Department of Energy

Subject: Durango, Colorado, Disposal Site, Revised Long-Term Surveillance Plan

Long-Term Surveillance Plan for the Durango, Colorado, Disposal Site

April 2015

Figure 6. Map of the Durango, Colorado, Disposal Site

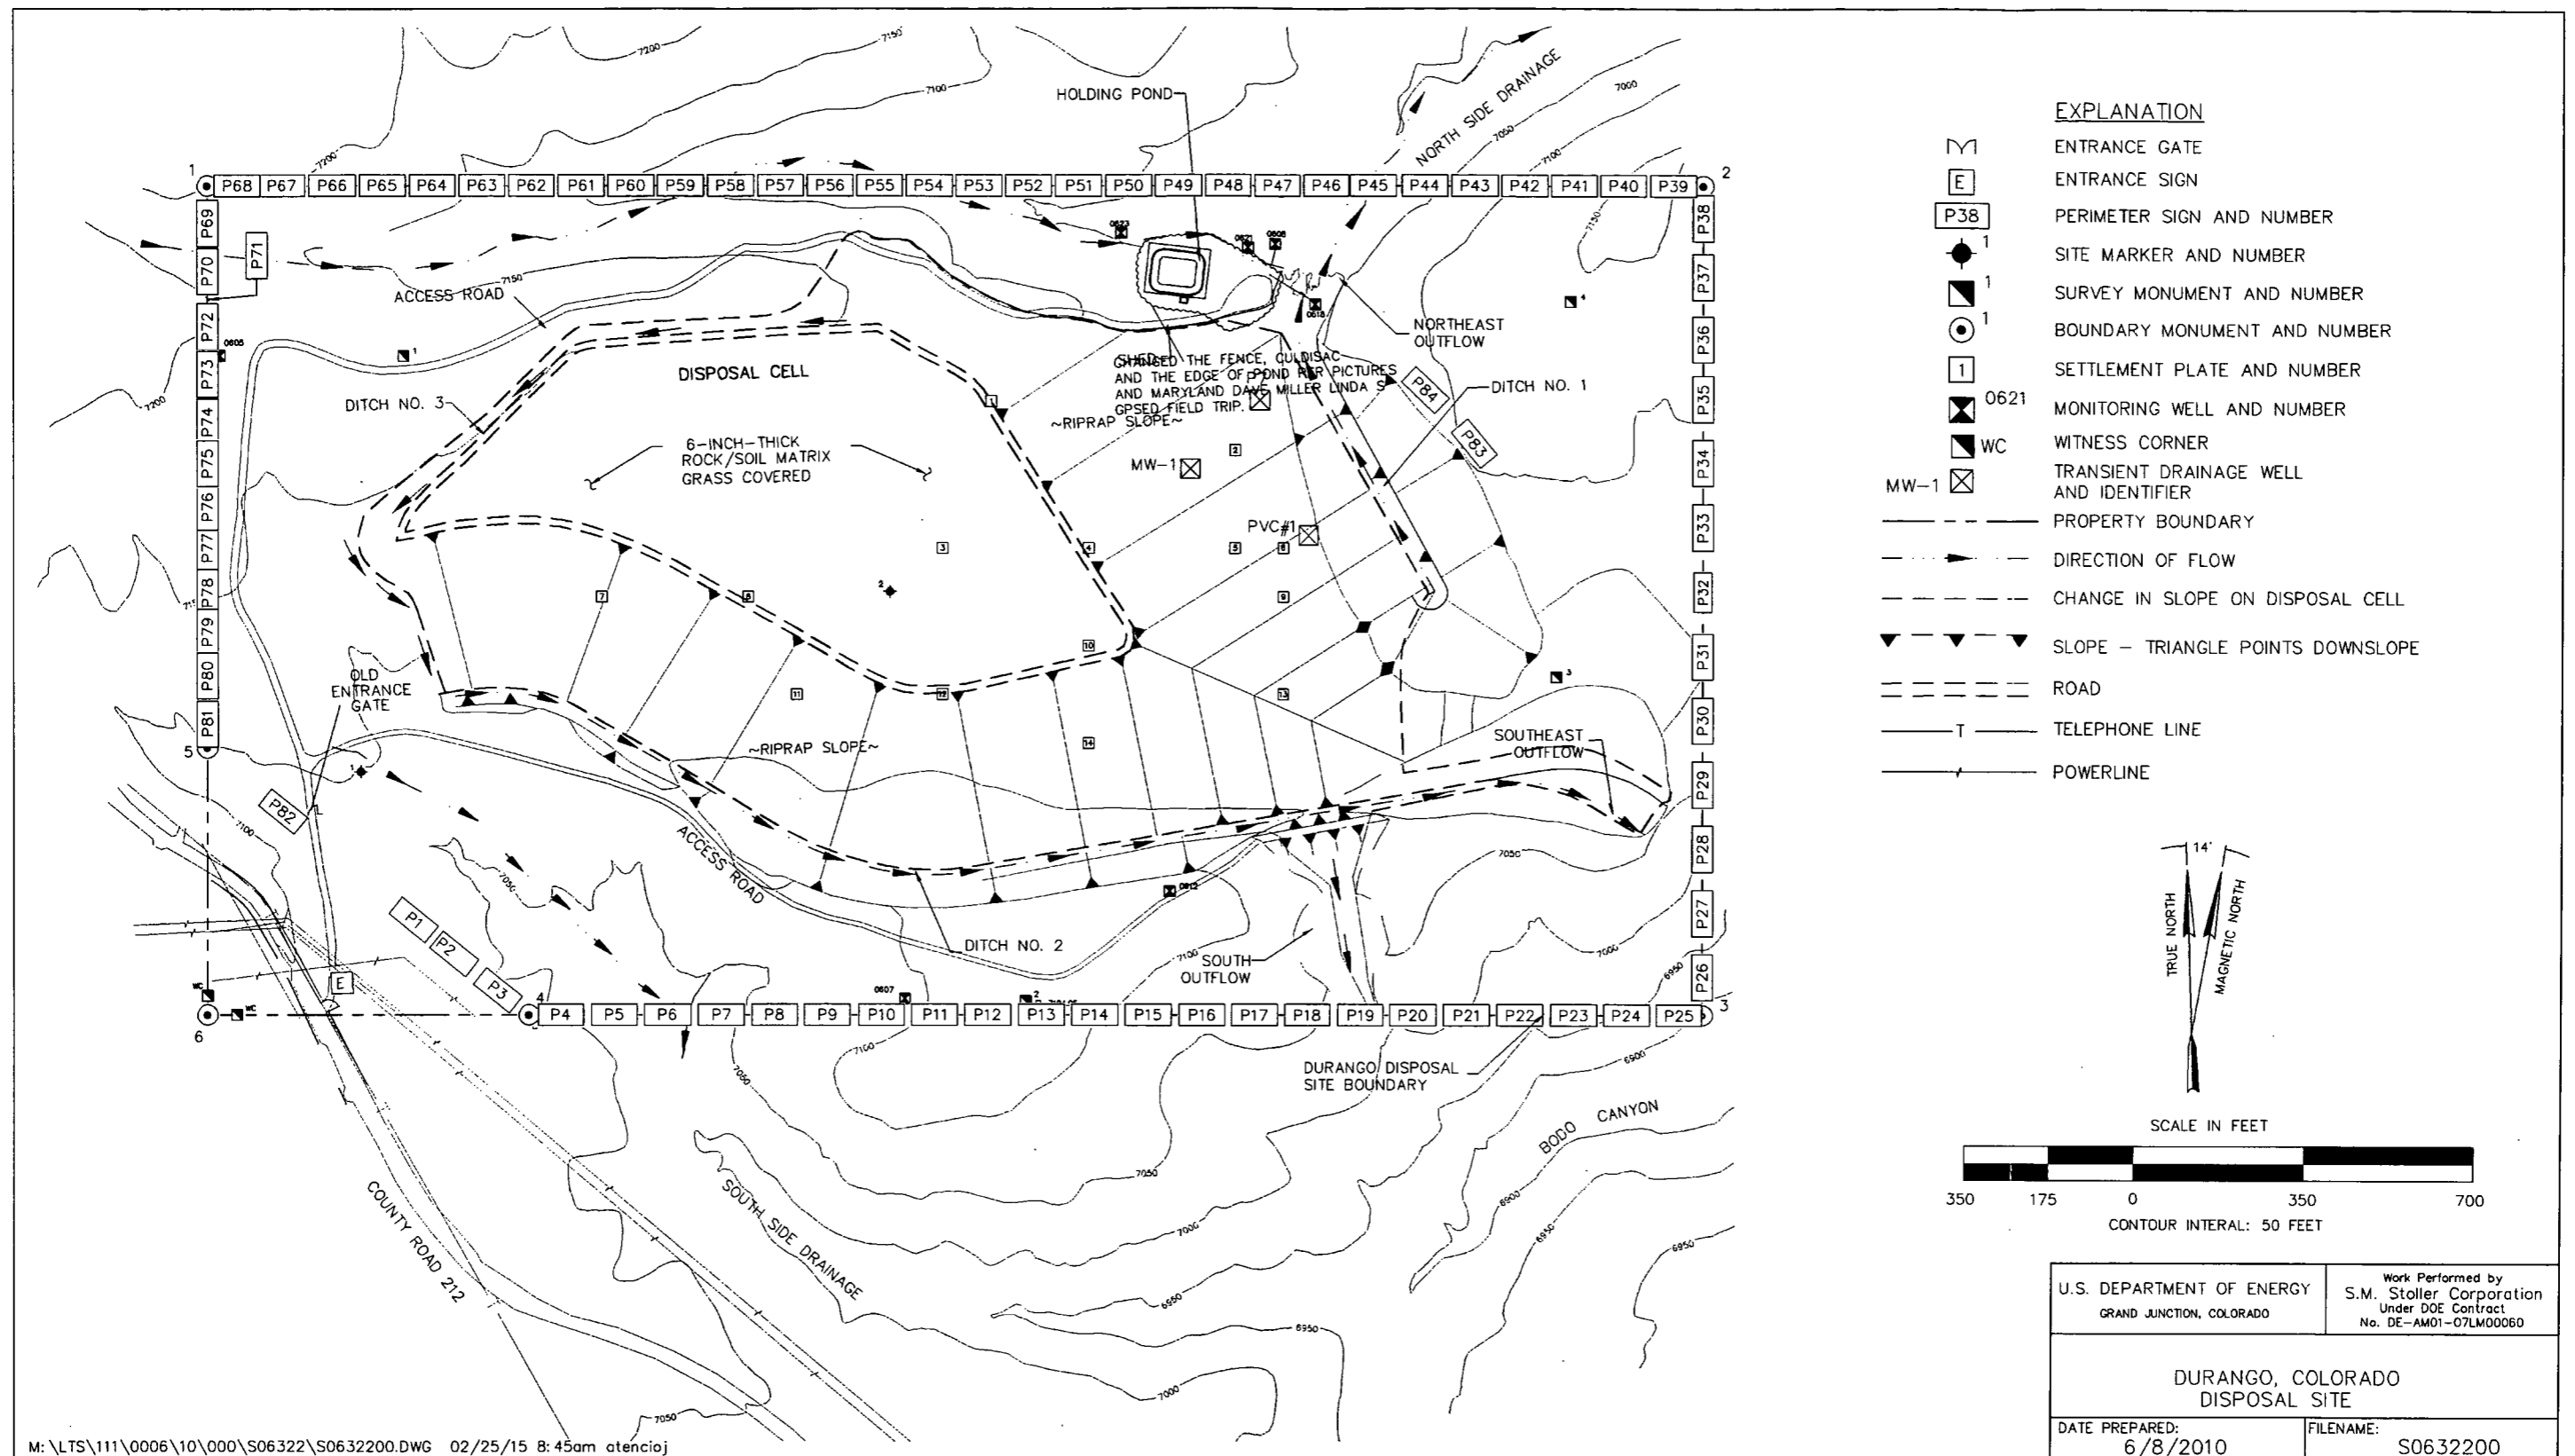
The Durango disposal site was licensed on June 18, 1996. The U.S. Nuclear Regulatory Commission (NRC) concurred with the original LTSP in September 1996 (Appendix A). NRC concurred with a revised LTSP in 2011 to incorporate the potential for beneficial reuse of some of the Durango Disposal Site property. This 2015 LTSP incorporates revisions to the requirements for inspection site boundary signs during annual inspections, see Section 2.2.7 and Figure 6.

Survey monuments (SM), boundary monuments (BM), site markers (SMK), and entrance and perimeter signs are the permanent surveillance features at the disposal site. Five boundary monuments define the corners of the unfenced perimeter of the disposal site. Eighty-two warning signs are placed around the perimeter of the disposal site (Figure 6).

To ensure the health and safety of inspectors during annual inspections, DOE-LM will discontinue visual inspection of perimeter signs 40, 41, 42 and 43, located along the north boundary of the site, beginning with the 2015 annual inspection. DOE-LM has discussed this change to the requirements of the LTSP with the Colorado Department of Public Health and Environment (CDPHE). The CDPHE representatives who participate in the annual site inspection fully agree with DOE-LM that visual inspection of these four perimeter signs should be discontinued; that the steep hillside and dense vegetation are more of a deterrent to trespass onto the site in this area than the signs.

Figure 9. Perimeter Sign, Durango, Colorado, Disposal Site

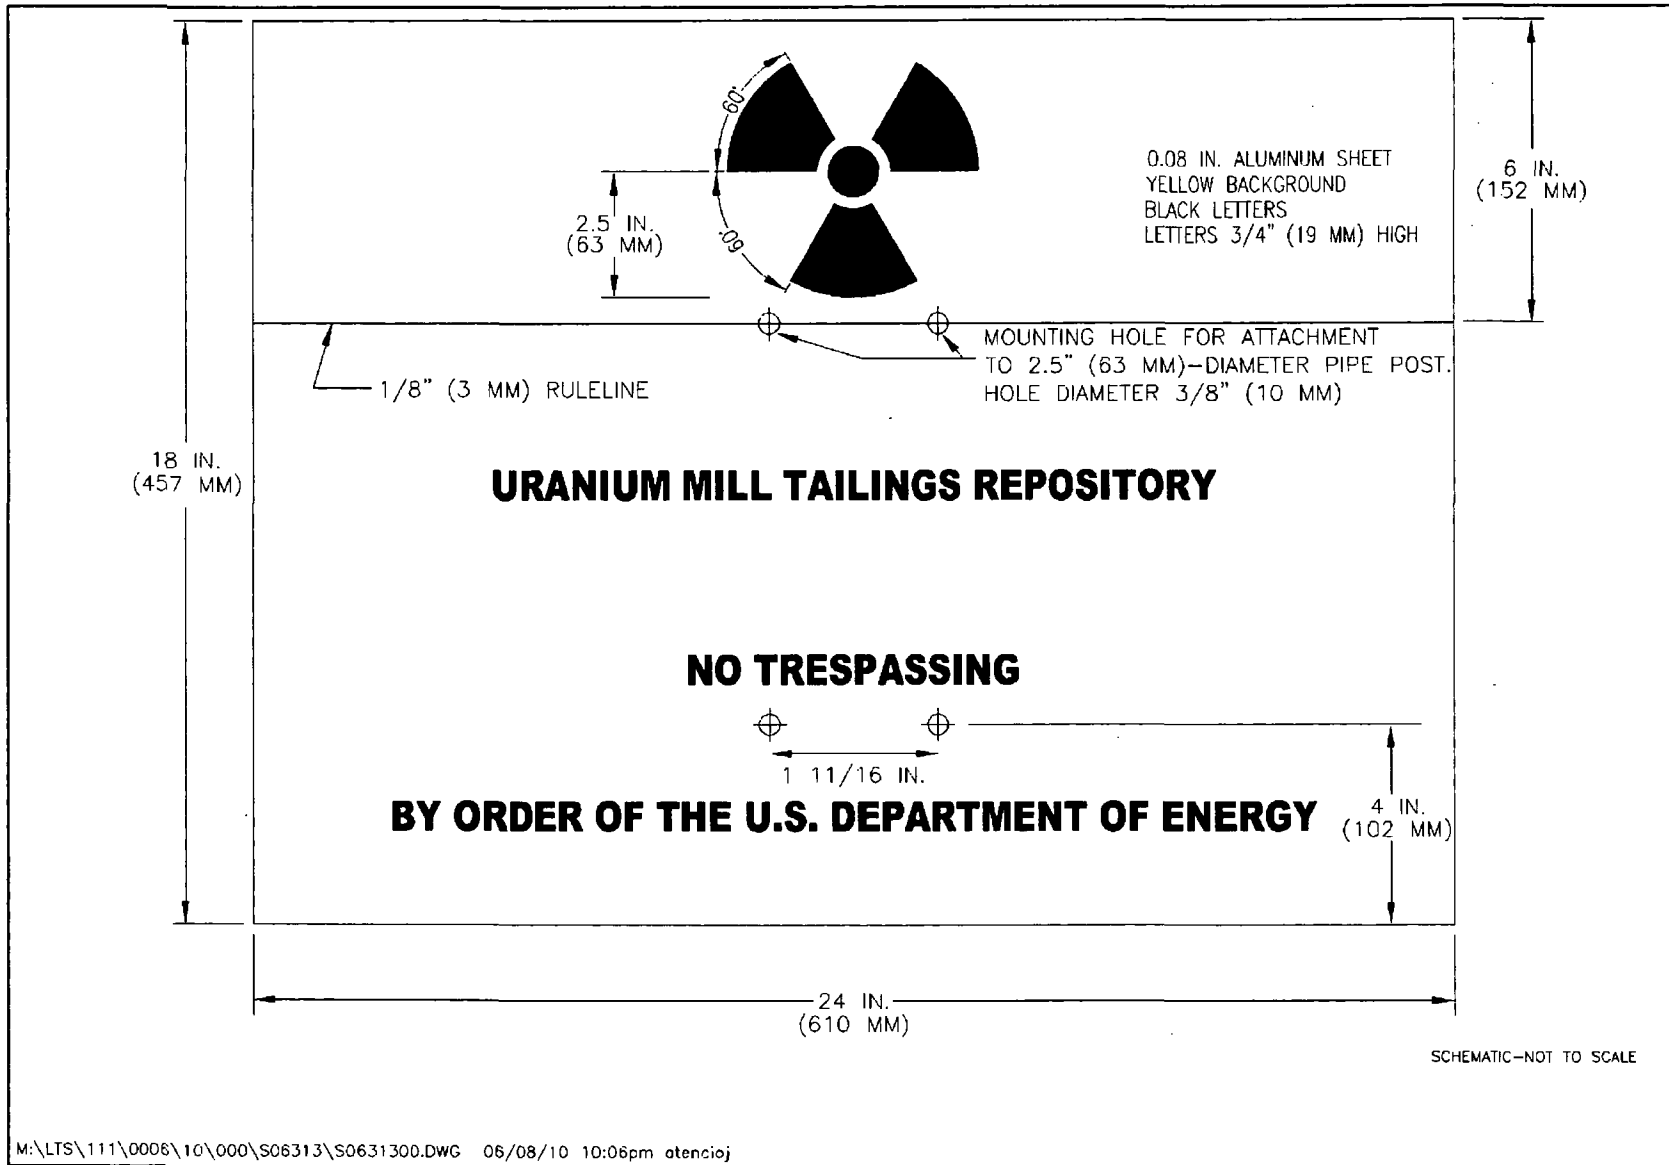
Entrance and Perimeter Signs—The site entrance sign (Figure 8) is at the entrance gate. In addition to the entrance sign, 82 perimeter signs (Figure 9) mark the boundary around most of the site, with two additional signs (numbered 83 and 84) located inside the site boundary (Table 2 and Figure 6). The two signs located inside the site boundary (83 and 84) were installed in 2015. These signs were placed in an area near the northeast corner of the site to supplement perimeter signs 40, 41, 42, and 43. Perimeter signs 40, 41, 42, and 43 are located on a steep and densely vegetated hillside, which acts as a natural deterrent; and the signs are not clearly visible. Annual inspection of signs 40 through 43 will not be included unless the dense vegetation recedes. Signs 83 and 84 are included in the inspection. These signs display the international trefoil symbol indicating the presence of radioactive materials. They also state that the disposal site is U.S. Government property and that trespassing is forbidden. The entrance sign has the same information as the perimeter signs, plus the name of the site and the telephone numbers of DOE and CDPHE offices (Figure 8).
